## Technical Service Bulletin

## Component Change

TSB-Y10-002

Flush Mount CO<sub>2</sub> Fill Box Modification

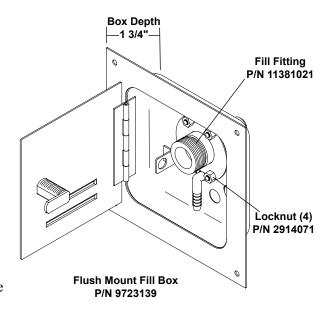
The brass fill fitting inside the fill box will become worn or may be damaged over time after repeated  $CO_2$  delivery connections. It will eventually need to be replaced. To enable its easy replacement, the fill fitting (P/N 11381021) is simply fastened onto four studs in the fill box using 1/4"-20 stainless steel locknuts (P/N 2914071.) The box does not need to be removed to replace the fill fitting. In fill boxes manufactured before this modification, replacement of the fill fitting (P/N 11014459) requires removal of a mounting plate inside the box, and removal and replacement of six mounting rivets.

This product modification is intended to simplify fill box maintenance. It was made standard after prototype fill boxes were thoroughly and successfully evaluated in field service. The part number (9723139) for the flush mount fill box has not changed.

**Note:** When replacing a fill fitting in the modified fill box, the lock nuts should be tightened to a torque not to exceed 100 inch-pounds to avoid breaking the mounting studs.
